## Proposal for Supplement 2 to the 00 and 01 series of amendments of Regulation No. 135 (Pole Side Impact)

The text reproduced below was prepared by the experts from France. It proposes a supplement to UN Regulation No. 135 to include similar requirements and test protocol for door opening evaluation as already adopted for UN Regulation No. 95 during the GRSP 63rd session (ECE/TRANS/WP.29/GRSP/63, para. 27 modified by annex VIII). The modifications to the current text of UN Regulation No. 135 are marked in bold for new characters and strikethrough for deleted characters.

**Figure**

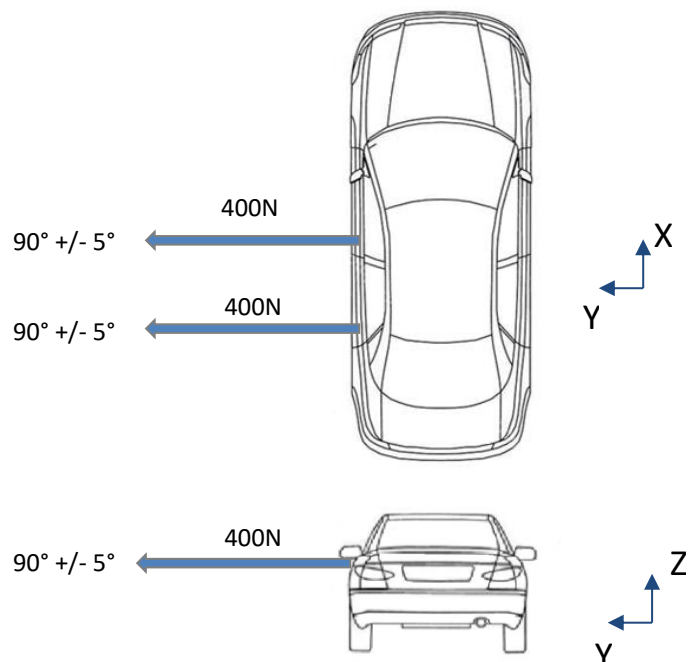
- (a) **if it is clearly visible, that the door lock is latched; or**
- (b) **if the door does not open under a static tractive force of at least 400 N in the y-direction applied to the door, according to the Figure below, as close as possible to the window sill and to the edge of the door opposite to the hinged side, except to the door handle itself.**
